Work Order ID 85824

Item Name: Replacement Skidtube

DESIGN CP	DRAWN BY PH	DART AEROSPACE USA, INC. PORT HADLOCK, WA	
CHECKED [Signature]	APPROVED [Signature]	DRAWING NO. D3274	REV. D SHEET 1 OF 4
DATE 06.12.19		TITLE SKIDTUBE ASSEMBLY	SCALE NTS
A	04.03.15	NEW ISSUE	
B	04.08.09	MOVE SADDLE HOLE: 42.14 WAS 42.76	
C	05.03.16	ADD -043; NEW INSERTS	
D	06.12.19	NEW INSERTS, SS WEARSHOE + GASKET

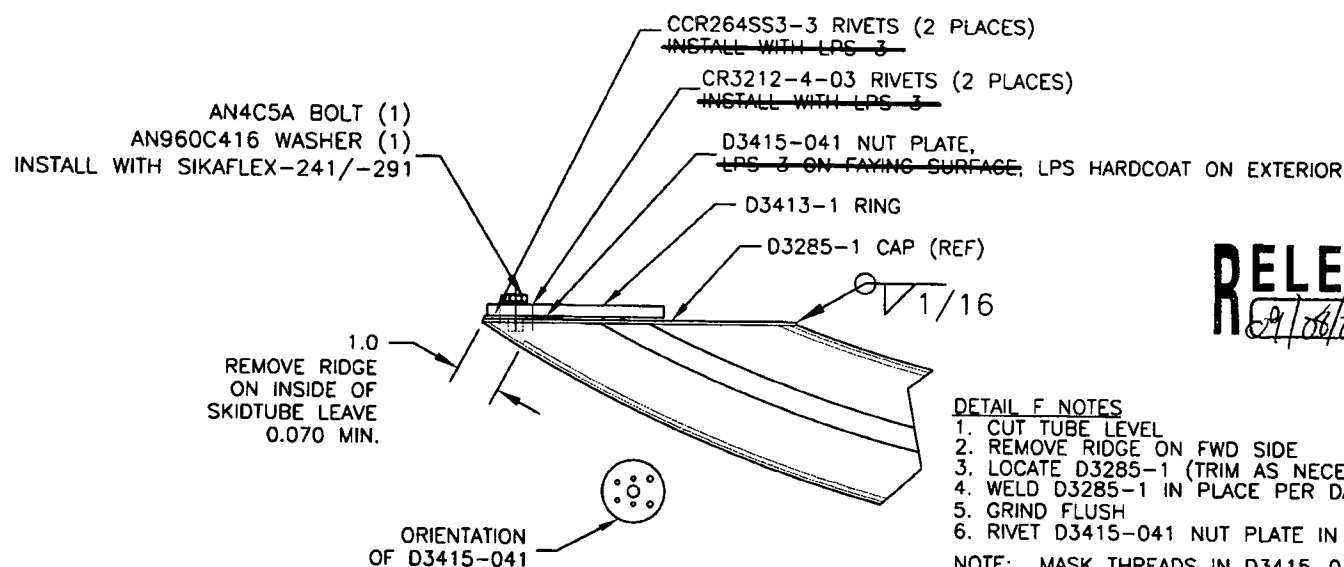
LPS-3 IS NO LONGER USED DURING ASSEMBLY OF SKIDTUBE.

AMEND NOTE 8: ~~"SPRAY INSIDE OF TUBE WITH A COAT OF LPS LABORATORIES 'LPS 3' AFTER FINISH AND INSTALLATION OF INSERTS.~~
COAT ALL EXPOSED FASTENERS WITH LPS LABORATORIES 'LPS PROCYON' AFTER FINAL ASSEMBLY, CLEAN EXCESS OFF
POWDER COATING WITH MEK DEGREASER."

AMEND DETAIL F AS SHOWN:

1. CUT TUBE LEVEL
2. REMOVE RIDGE ON FWD SIDE
3. LOCATE D3285-1 (TRIM AS NECESSARY)
4. WELD D3285-1 IN PLACE PER DART QSI 004
5. GRIND FLUSH
6. RIVET D3415-041 NUT PLATE IN PLACE
